### City of Cannon Beach Tree Removal Application

Re: Tree hazard evaluation.

#### **Tree Removal Permit Application Review - 191 E Madison**

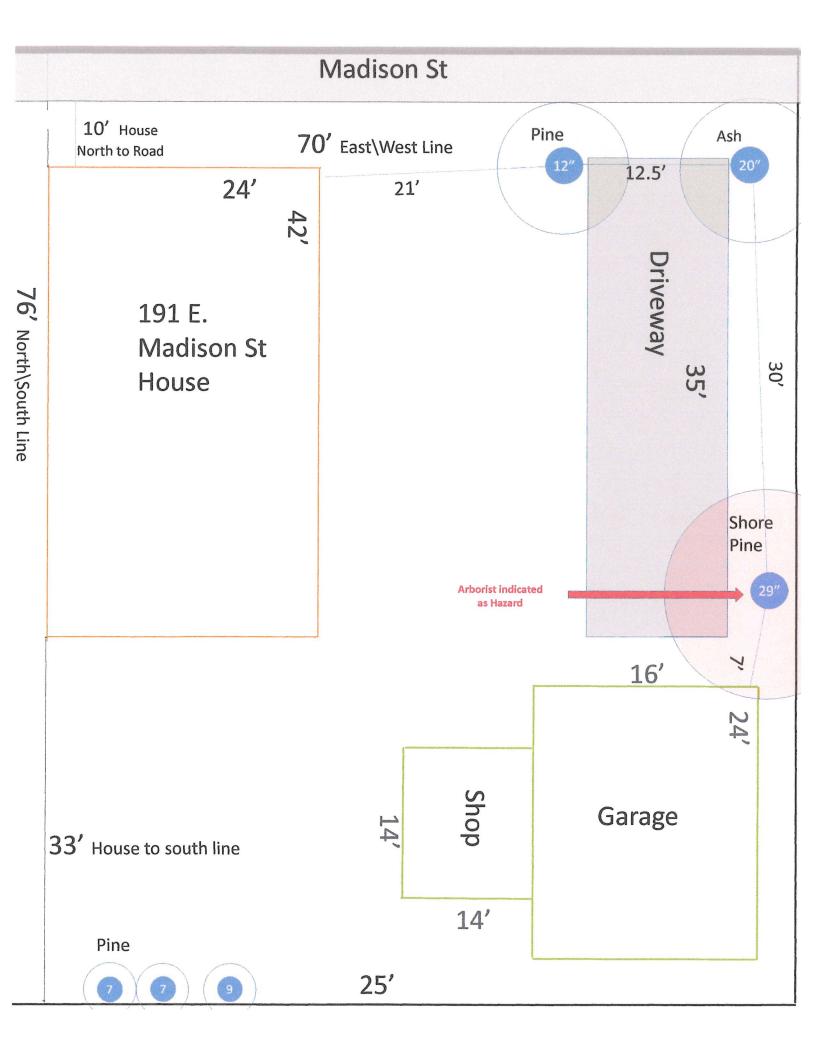
Observed: Coast pine. 26" DBH. Height 40' Multiple stems(4). Tight angle between stems.

Evidence of sap flow stain mainly on east side of tree.

Reported: Sap flow during storm event along with root plate upheaval.

Further pruning not an option at this time due to root system disturbance coupled with high potential for crown component failure.

Removal recommended per hazard evaluation (attached).

Replacement tree/s required. Recommended species for the east side of the driveway is Hinoki cypress given space restrictions. Quantity (3).
